COLONIAL HILLS SUBDIVISION, UNIT 6

The purpose of this application is to subdivide one parcel into 34 lots.

APPLICATION NUMBER 8 DATE October 5, 2006

DETAIL SITE PLAN

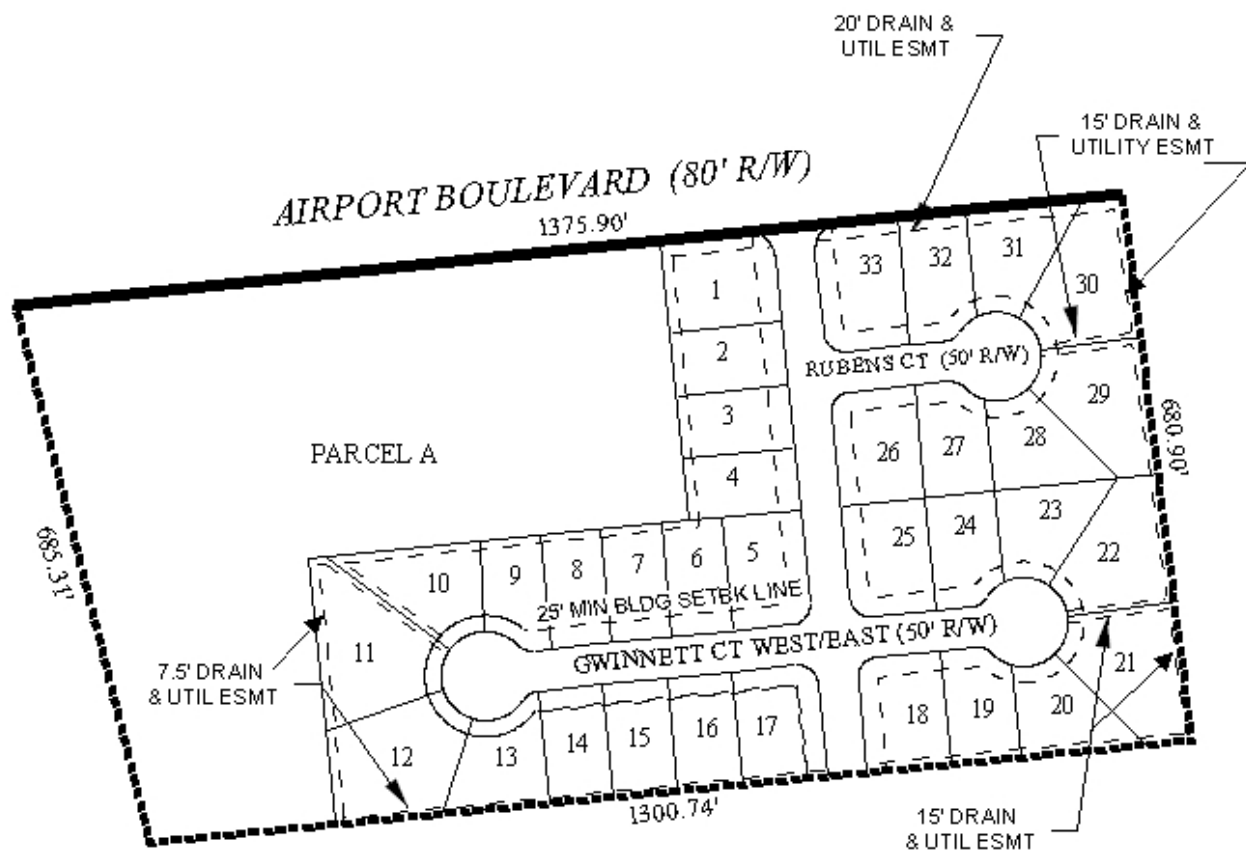
The site fronts onto Airport Boulevard, a proposed major street, and a street stub for Colonial Crossing, a minor street. As a proposed major street, Airport Boulevard should have a right-of-way width of 100 feet, thus additional right-of-way sufficient to provide 50-feet, as measured from the centerline, should be dedicated to Mobile County.

Access management is a concern due to site fronting onto Airport Boulevard, and the proposed subdivision creating a corner lot condition. Lots 1 and 30-33 should be denied direct access to Airport Boulevard, while Lot 34, which is labeled as "Parcel A" on the plat, should be limited to a maximum of two curb-cuts onto Airport Boulevard, with the size, design and location to be approved by Mobile County Engineering, and conform to AASHTO standards. Furthermore, "Parcel A" should be relabeled as Lot 34 for the final plat, if approved.

As Lot 34 (Parcel A) may be for commercial development, and as the entire development site is in the county, a note should be placed on the final plat stating that any lots which are developed commercially and adjoin residentially developed property must provide a buffer, in compliance with Section V.A.7. of the Subdivision Regulations.

The 25-foot minimum building setback line, required in Section V.D.9., is not accurately depicted on the preliminary plat. The setback line should be show for all properties, and should be from all street frontages, including those lots with frontages on Airport Boulevard. It also appears that the setback distance decreases to 20 feet around the cul-de-sacs. The plat should be revised to show the correct setback from all street frontages, including those lots that have frontage onto Airport Boulevard.

Stormwater detention facilities are not depicted on the plat, however, compliance with the City of Mobile stormwater and flood control ordinances may be required. A letter from a licensed engineer certifying compliance with the City's stormwater and flood control ordinances should be submitted to the Planning Section of Urban Development prior to the signing of the final plat, if approved.

While all lots appear to meet minimum size requirements, the plat should be revised to label each lot with the size in square feet, or provide a table on the plat with the same information.

Finally, there appears to be an error in the written legal description and a bearing along the Southern boundary of the site. The plat should be revised to correct the errors.

Based on the preceding, this application is recommended for Tentative Approval, subject to the following conditions: 1) dedication of sufficient right-of-way to provide a minimum of 50 feet from the centerline of Airport Boulevard; 2) renaming of "Parcel A" to "Lot 34"; 3) placement of a note on the final plat stating that Lots 1 and 30-33 are denied direct access to Airport Boulevard, and that Lot 34 is limited to a maximum of two curb-cuts onto Airport Boulevard, with the size, design and location to be approved by Mobile County Engineering and conform to AASHTO standards; 4) placement of a note on the final plat stating that any lots which are developed commercially and adjoin residentially developed property must provide a buffer, in compliance with Section V.A.7. of the Subdivision Regulations; 5) revision of the plat to ensure that the 25-foot minimum building setback line is accurately depicted as 25-feet, as adjusted for right-of-way dedication for Airport Boulevard, for all lots with frontage on a public street, including those lots which may have double-frontage or that abut cul-de-sacs; 6) provision of a certification letter from a licensed engineer to the Planning Section of Urban Development, certifying that the stormwater detention and drainage facilities comply with the City of Mobile stormwater and flood control ordinances, prior to the signing and recording of the final plat; 7) labeling of all lots with size in square feet, or provision of a table with the lot size information on the plat; and 8) correction of the written legal description and the labeled bearings along the Southern boundary of the site.
